Re: Trout Brook Realty Advisors Inc.
(Formerly West Hartford Housing Corporation)
Mixed-Use Residential and Retail Development
616 New Park Avenue

**Request for Modification of Screening and Landscaping Requirements
West Hartford Zoning Regulations - Section 177-34
Previously Approved Site Plan Application #1280**

PLANTING PLAN

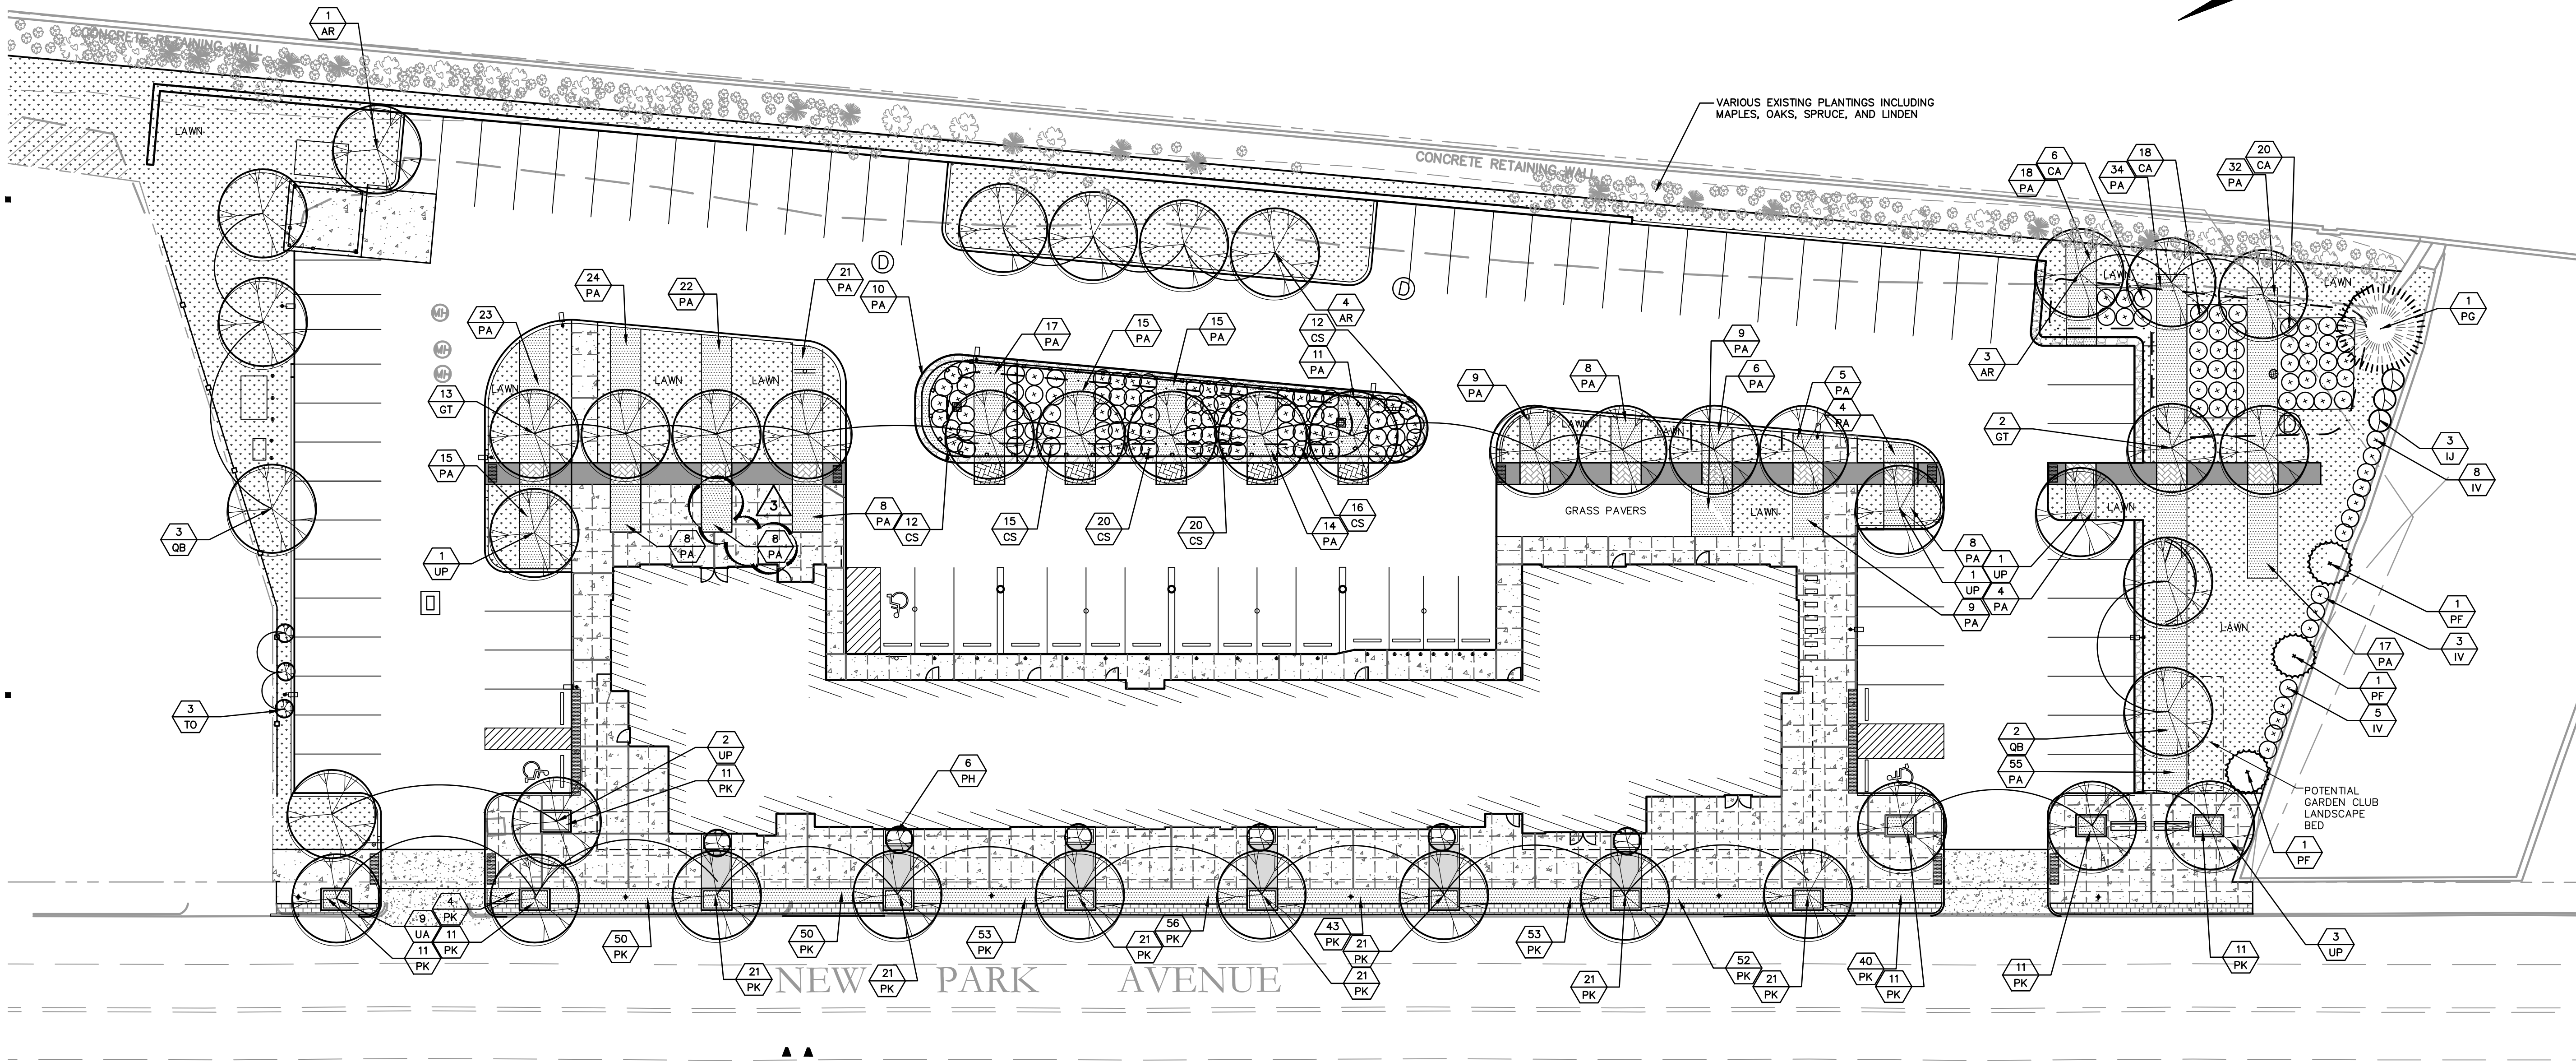
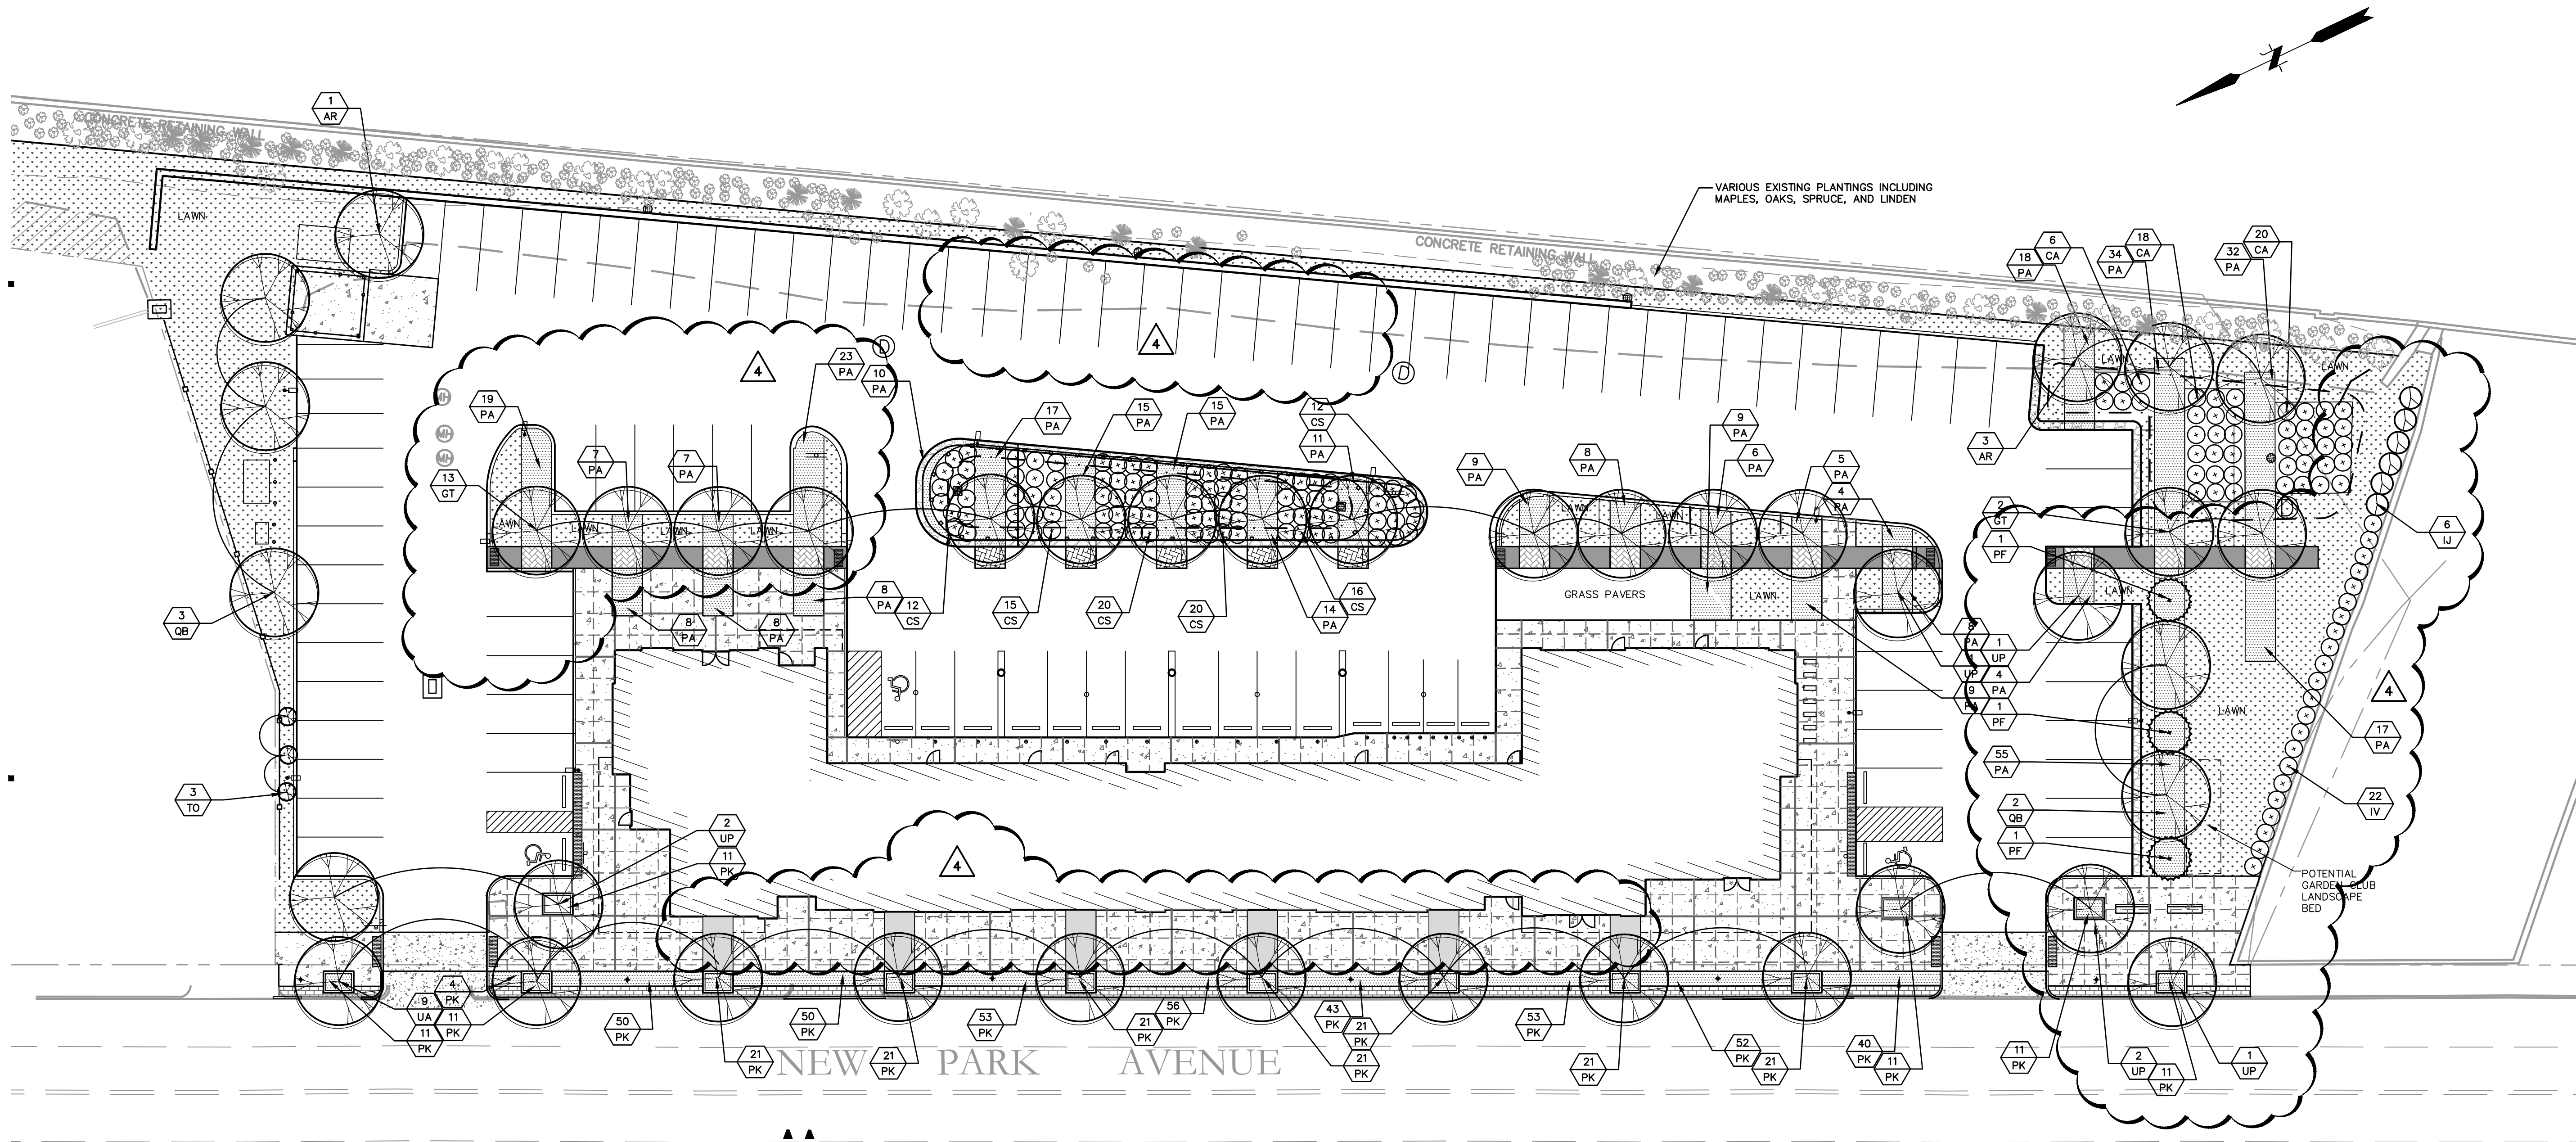
Specifically, TBRA requests a modification of the screening and landscaping requirements under Section 177-34 of the Zoning Regulations regarding Type A screening in the front yard for a residential use in an IG zone. A modification to the requirements is permitted under Section 177-34 (E) where the Plan and Zoning Commission finds that equivalent or superior screening will be provided.

The approved site plan shows two sets of tree planters along New Park Avenue. One set of planters is within the right-of-way for New Park Avenue and is consistent with the streetscape design concept envisioned by the Town. A second set of planters was added within the front yard of the site along the building face to satisfy the Type A screening requirements. The second set of planters was added because the streetscape trees, while within close proximity, are not located within the property boundary, and therefore cannot be considered toward the Type A screening requirement.

We believe that this "double" row of tree planters, while required by regulation, will result in a less desirable streetscape along New Park Avenue. The additional trees will look cluttered and will not work well with the building architecture. We believe that the streetscape trees proposed along New Park Avenue will provide the proper screening that was envisioned by Section 177-34 of the

regulations. In accordance with Section 177-34 (E), we ask that the Commission consider our request for this modification.
